Griffith Base Hospital Redevelopment – Modification 1

State Significant Development Modification Assessment Report (SSD-9838218-Mod-1)

September 2023

Figure 4 | Approved and proposed northern elevations (Source: Architectural Plans)

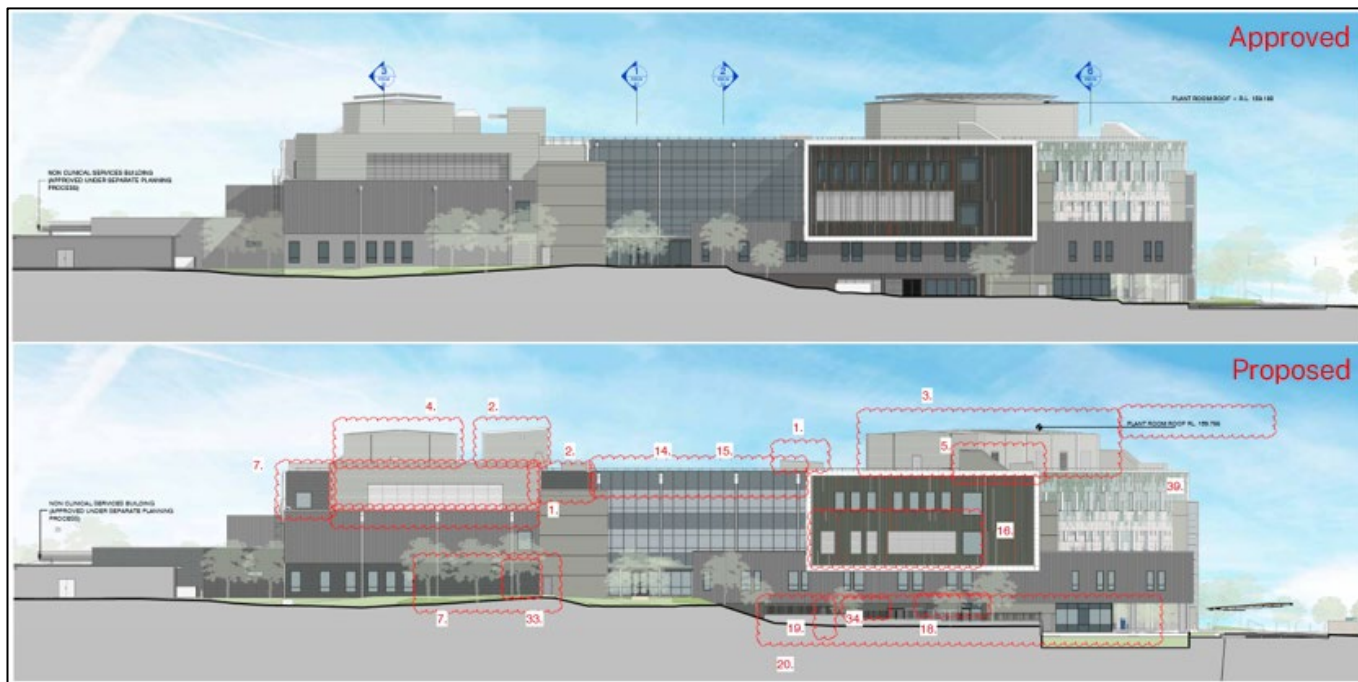
The application seeks to increase the height of the approved building by 890mm over Lifts 3 and 4 (RL 159.766). As shown in **Figure 3** below, the highest point of the building has shifted from the rooftop plant room (shown as Item 3) to the lift overrun above Lifts 3 and 4 (Item 2).

The lift overrun, which has an approximate area of 55sqm and is located approximately 100m from the nearest residential properties and adjoining streets, is proposed to be finished in a dark recessive colour. The Department considers the proposed building height increase above Lifts 3 and 4 to be minor and indistinguishable compared to the approved CSB. The proposed building height is

The proposed façade modifications include but are not limited to revisions to the colour and material of external wall cladding, alterations to and the addition of ventilation louvres, stair finish amendments and window and door design modifications.

The Department has assessed the proposed change in façade cladding material, from GRC to CFC, to be generally consistent with the originally approved materiality whilst maintaining the quality of the approved façade articulation. The Applicant’s Design Statement argues that the proposed material amendments are better aligned to the design objectives outlined within the Design Statement submitted as part of the approved EIS, which emphasised durability and maintenance, buildability, and cost effectiveness. The Department agrees in this regard.

The Department also agrees that the proposed colour palette would reinforce the appearance of a ‘strong’ base to the building in contrast to the ‘light’ glazing and louvres above, while the louvre panel and window adjustments would not adversely affect the level of façade articulation and massing. The Design Statement puts forward that the proposal is in keeping with the design quality and built form objectives of the approved development.

considered consistent with the intended bulk and scale of the approved building and no concerns are raised by the Department in this regard.

The Department is satisfied that the proposed modifications are consistent with the original design intent and preserve the approved built form, urban design and design quality. In summary, the proposed design modifications would have a neutral impact on the overall architectural and aesthetic quality of the approved development.
